Final RCRA Facility Investigation Phase 2 Work Plan Parcel 23 Revision 1.0

Fort Wingate Depot Activity
McKinley County, New Mexico

April 29, 2019

Army Response to October 31, 2018 Disapproval Letter
April 25, 2019

Previous Sample Locations with Analytes Exceeding 2019 NMED SSLs

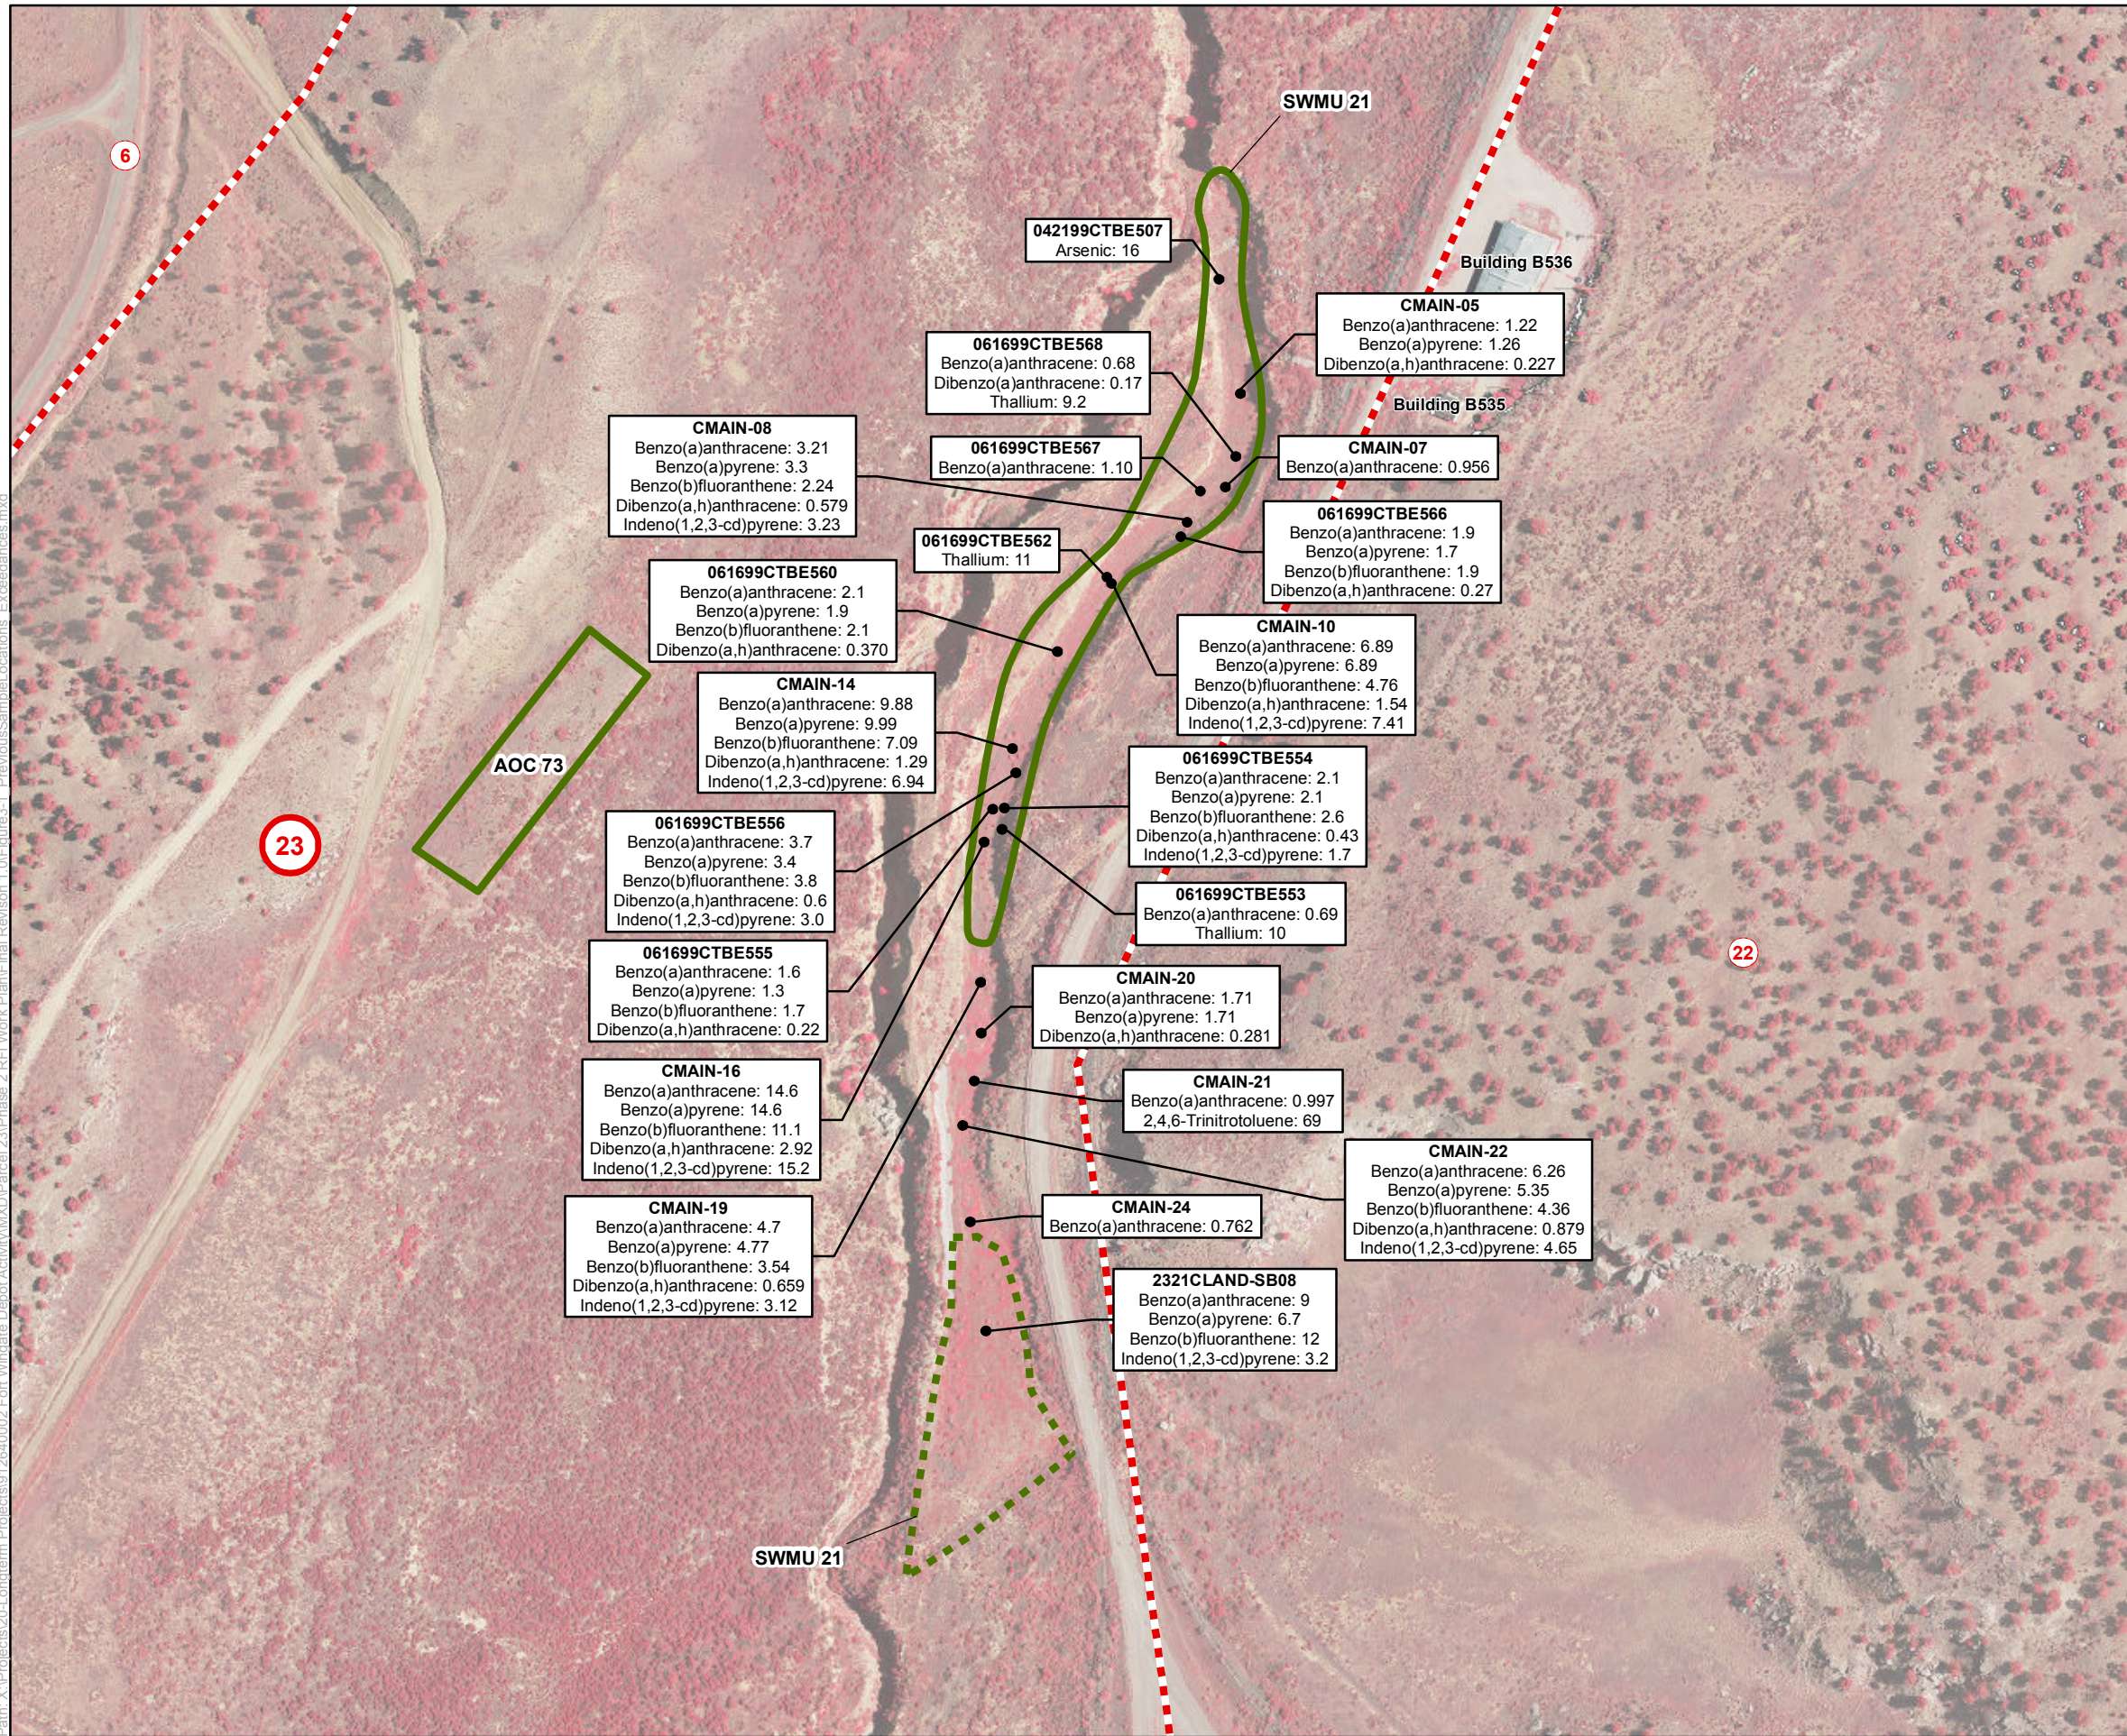
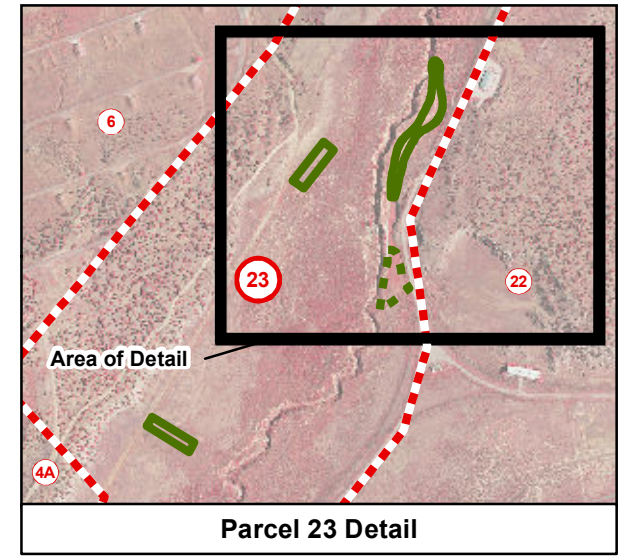
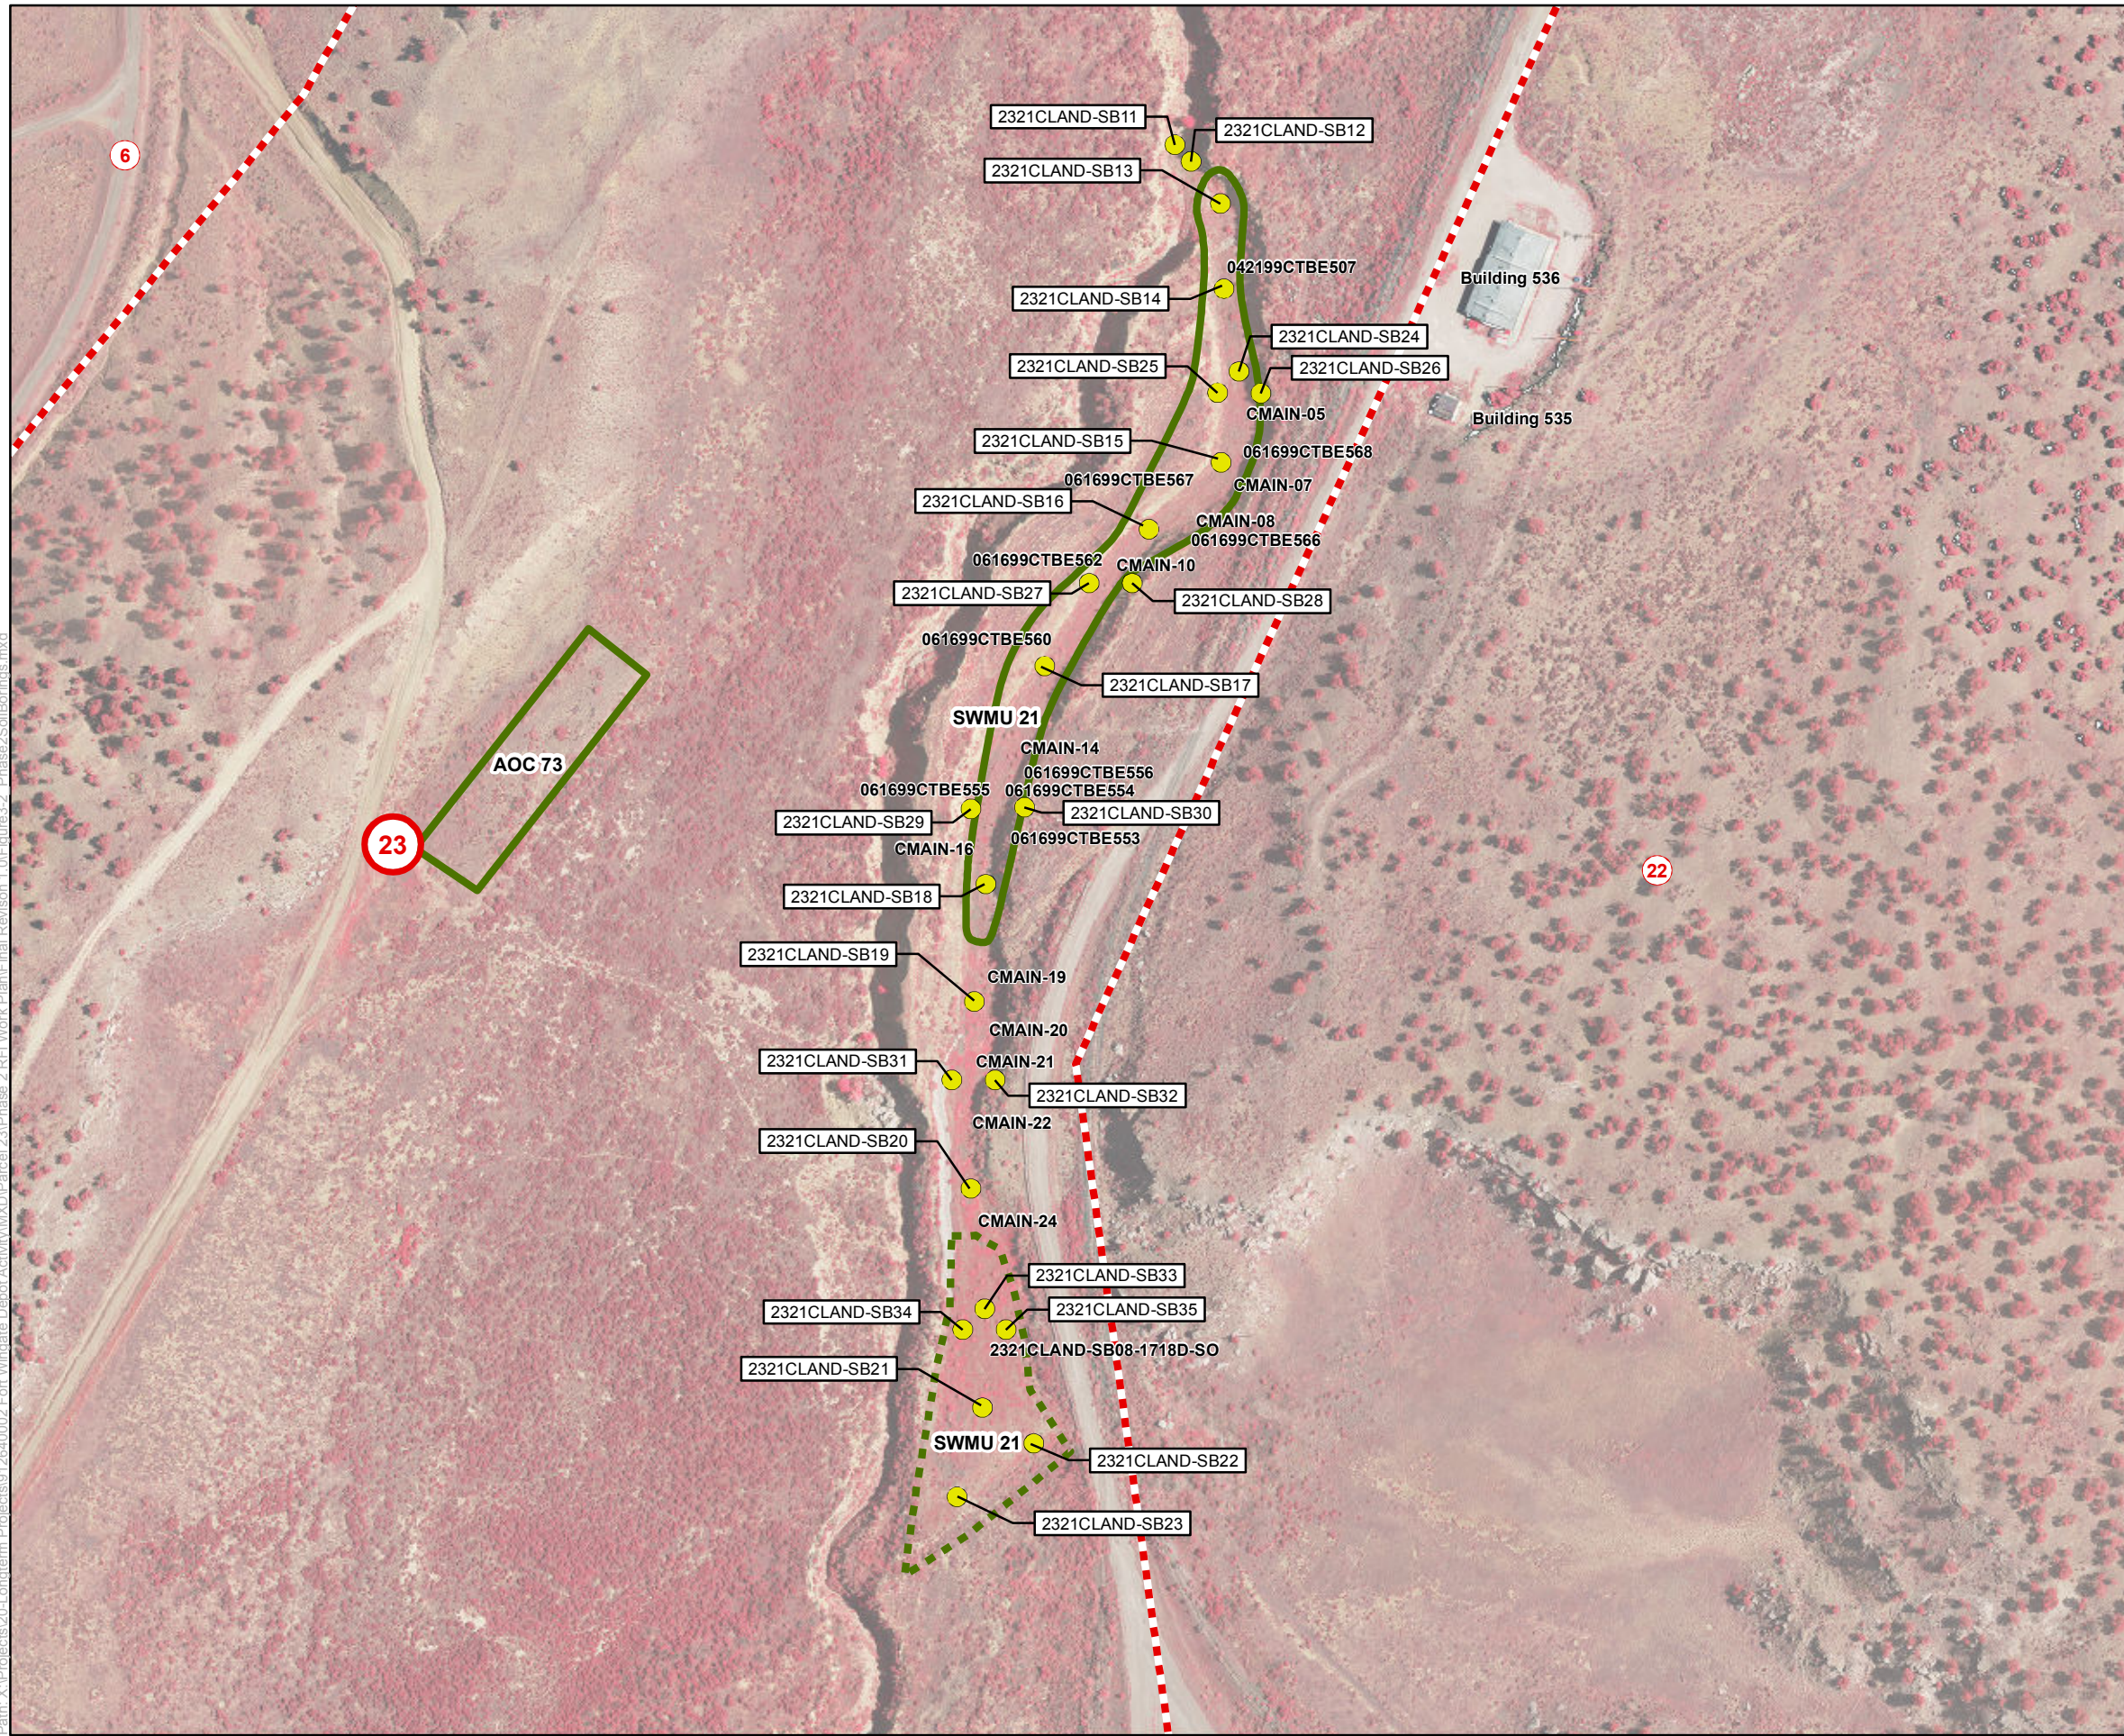
NMED Comment: The contaminant distribution shown in Figure 3-1, Previous Sample Locations with Analytes Exceeding 2017 NMED SSLs, suggests that the source area of potential groundwater contamination easily exceeds 0.5 acre. Since the DAF of 20 is protective of groundwater for a 0.5-acre source but not for a larger source area, the DAF values must be revised if groundwater is found to be affected. Discuss whether a DAF of 20 is appropriate for the site in the revised Work Plan.

NMED Comment: In Figure 3-1, a distribution of SVOC exceedances was observed in the area between the two boundaries as well as in the areas within the boundaries. Therefore, these two areas must be considered to be contiguous and must not be evaluated separately. In addition, the lateral extent of SVOC exceedances is not defined to the north and south along the arroyo. The extent of contamination has not been defined. The beef ingestion pathway must be evaluated in the Phase 2 Investigation Report. Revise the Work Plan accordingly.

Previous sample locations and analytes which exceed the lowest 2019 NMED SSLs for a residential receptor (which is either the direct contact SSL or the groundwater protection SSL) are summarized in **Tables 3-1** through **3-3** and illustrated in **Figure 3-1**.

The text (bullet item 2.) was revised to strike the sentence: "SWMU 21 consists of two separate, non-contiguous areas that may be evaluated separately." Reference to non-contiguous areas in other sections was also removed, including section 5.1.5, 5.2.4, and Figure 5-1.
